CITY OF ALBUQUERQUE

RE: **Jackson Middle School Cafeteria**
10600 Indian School NE
Request for Certificate of Occupancy – Permanent
Hydrology Final Inspection - Disapproved
Engineer's Stamp Date 5/23/17 (J21D029)
Certification Dated: 1/27/18

**BUILDING A
~CAFETERIA~
GRADING & DRAINAGE
PLAN**

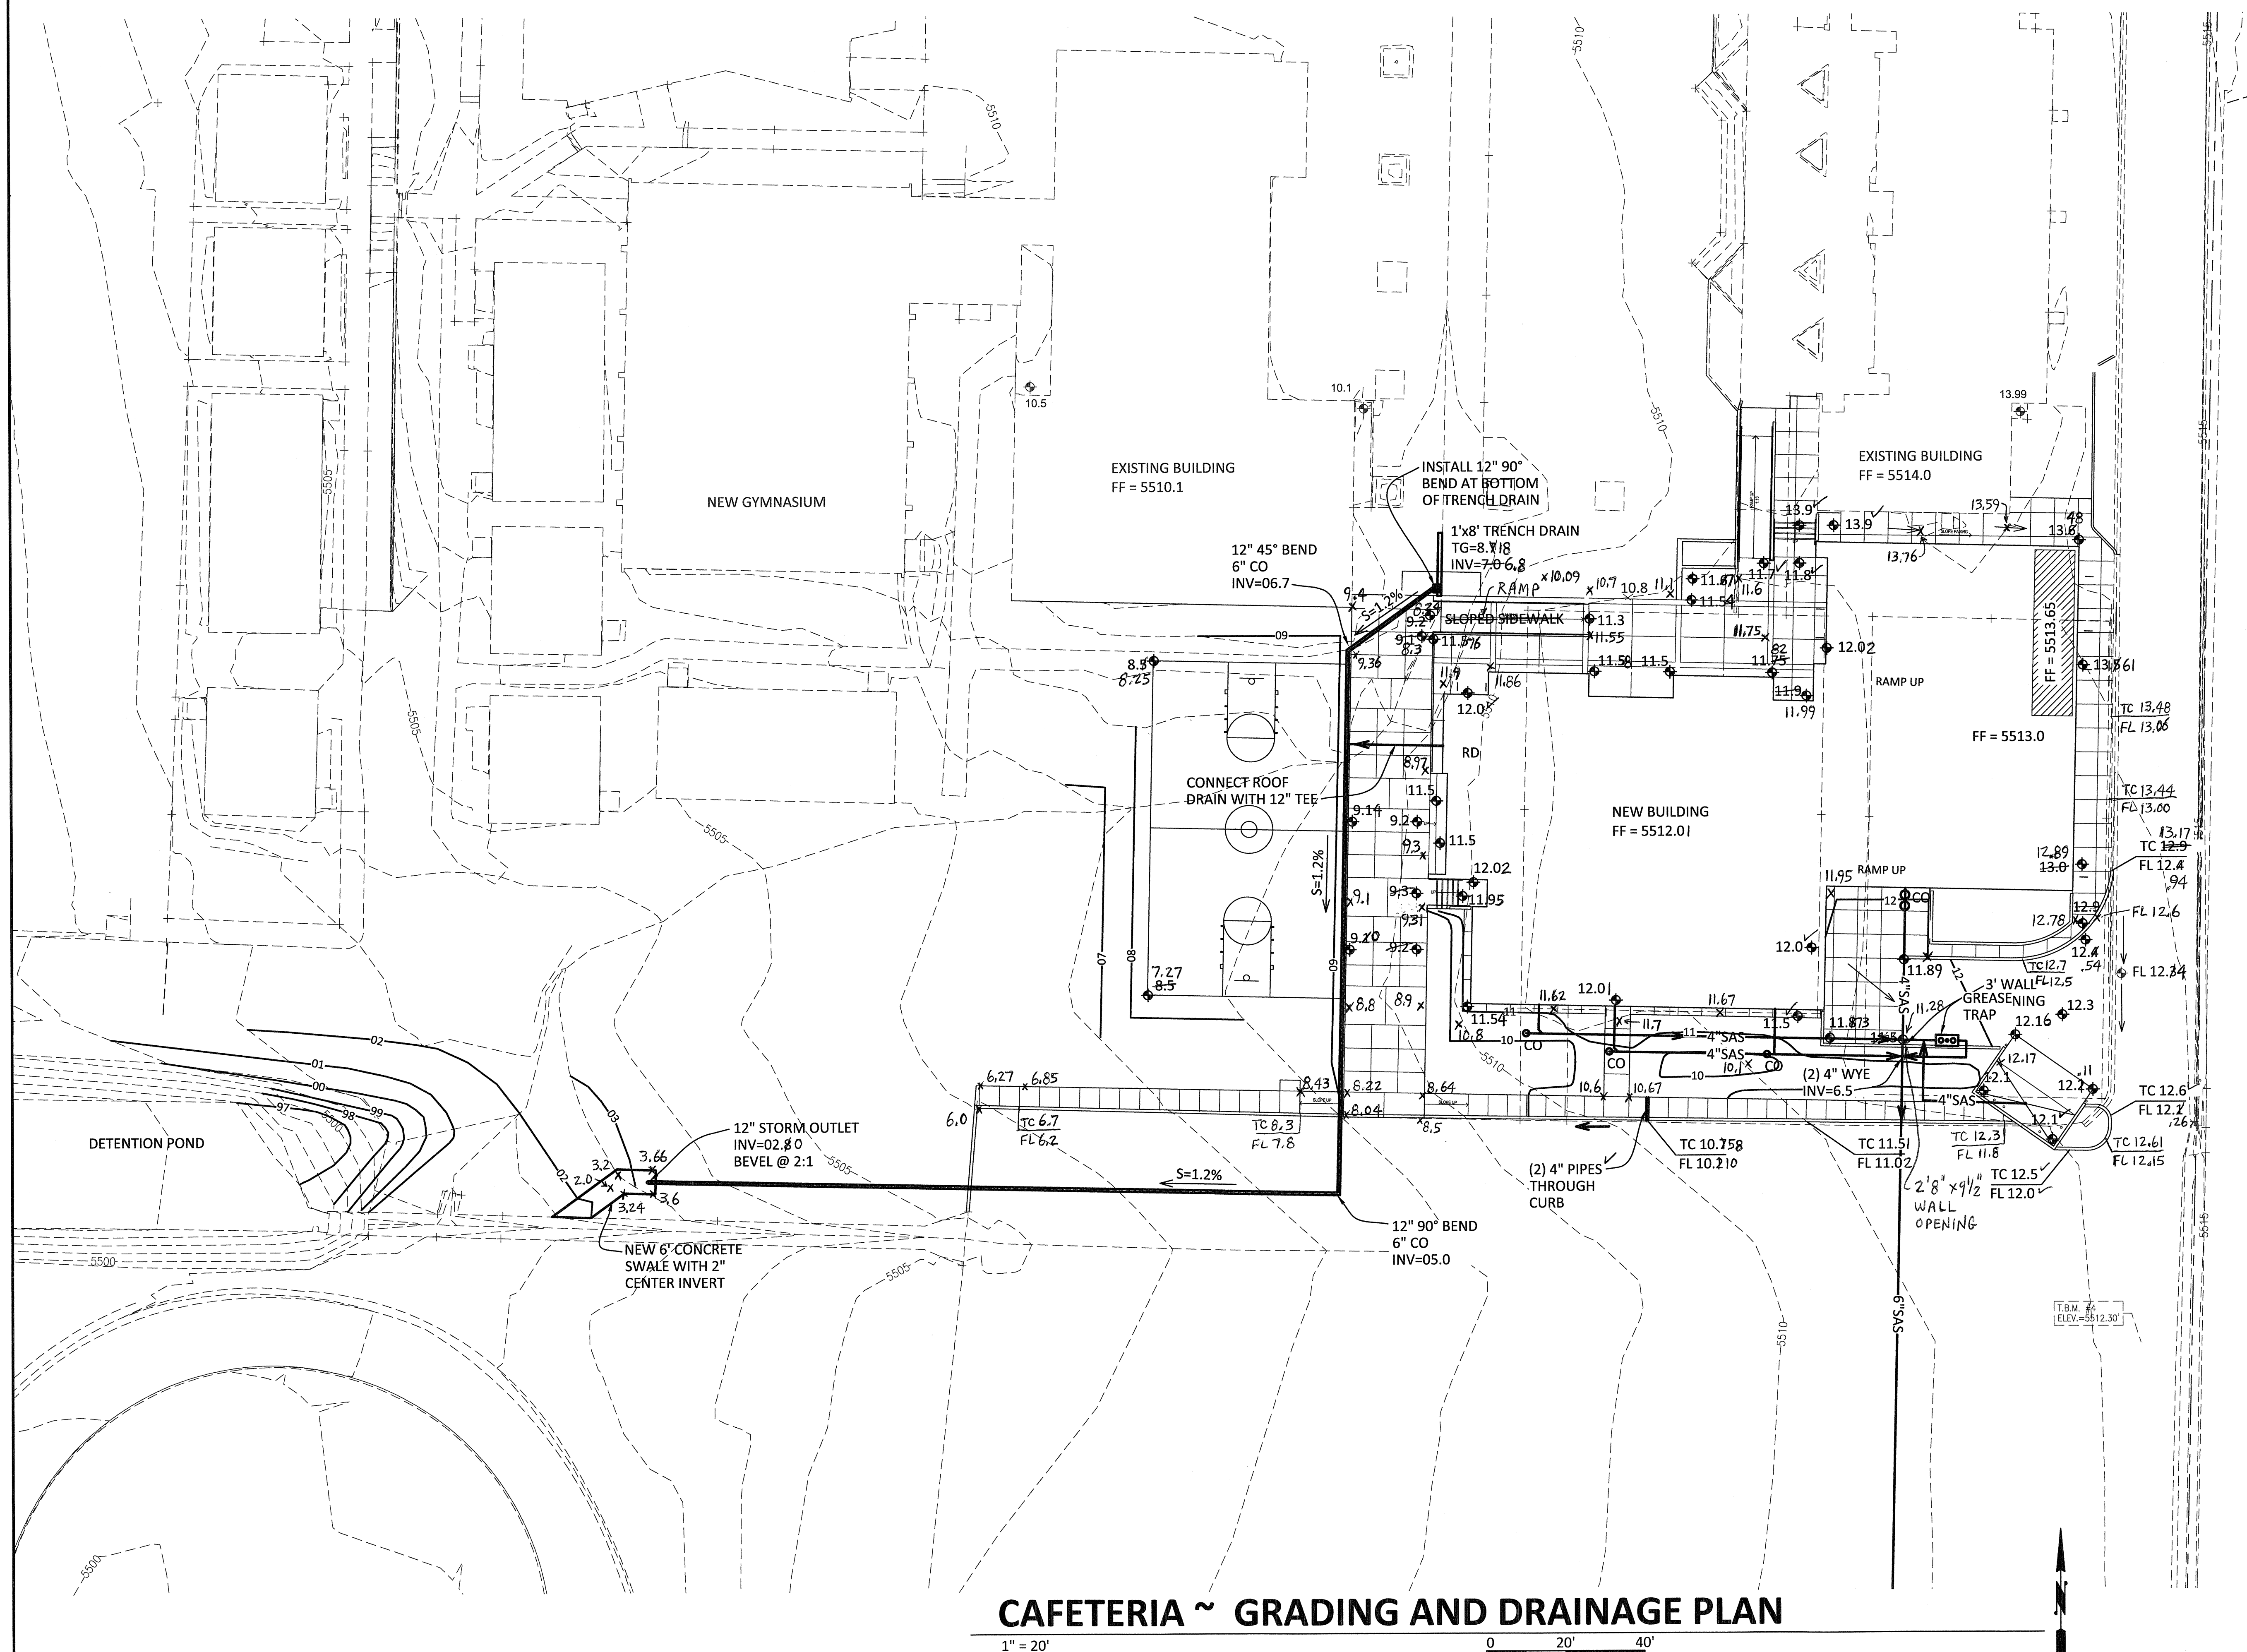
1. The detention pond needs to be excavated and enlarged as shown in the approved Grading and Drainage Plan. Once complete, the enlarged area will need to be surveyed, re-certified, and a new Engineer's Certification submitted to Hydrology.
